**Recall Service Bulletin
RSB22-240-001**

APPLIES TO: This service bulletin applies to certain 2021 through 2023 model year, Gladiator, Metro Star, FC-94, and KME Panther model emergency response chassis cabs built between January and September 2022.

NHTSA/TC Id: 22V778 / TC2022-603

REPLACING TIE ROD END CLAMPS WITH KIT FRK-22-1002 SELECT NON-DRIVE STEER AXLES BUILT 12/16/2021 THROUGH 5/16/2022

Figure 1

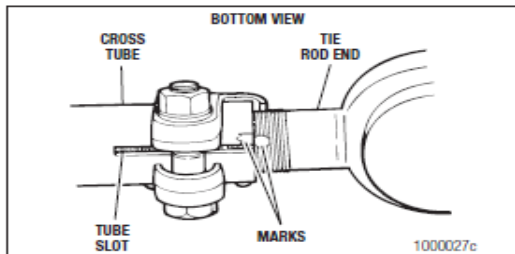
3. Use a paint pen to mark the position of both tie rod ends as shown. Be sure to mark it well so the tie rod end can be screwed back into the exact same position on the threads. Also count the amount of visible threads to confirm proper depth upon re-installation. Figure 1.

10. Thread the tie rod end back into the same position utilizing the paint pen marking. Exposed threads should match the value noted in Step 3.
11. Be sure that the clamp tab is firmly seated against the end of the cross tube. Align the clamp opening with the cross tube slot as shown in Figure 1. Tighten the clamp bolt nut to 150-175 lb-ft (203-237 Nm).

Figure 2

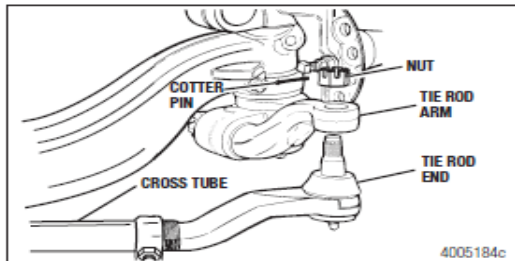
4. Remove the cotter pin and nut that fastens the tie rod end to the tie rod arm. Figure 2.

5. Disconnect the cross tube assembly from the tie rod arm. If available, use a tie rod end puller to separate the tie rod end from the tie rod arm. Figure 2. If necessary, use a leather or plastic mallet to tap on the end of the tie rod arm.
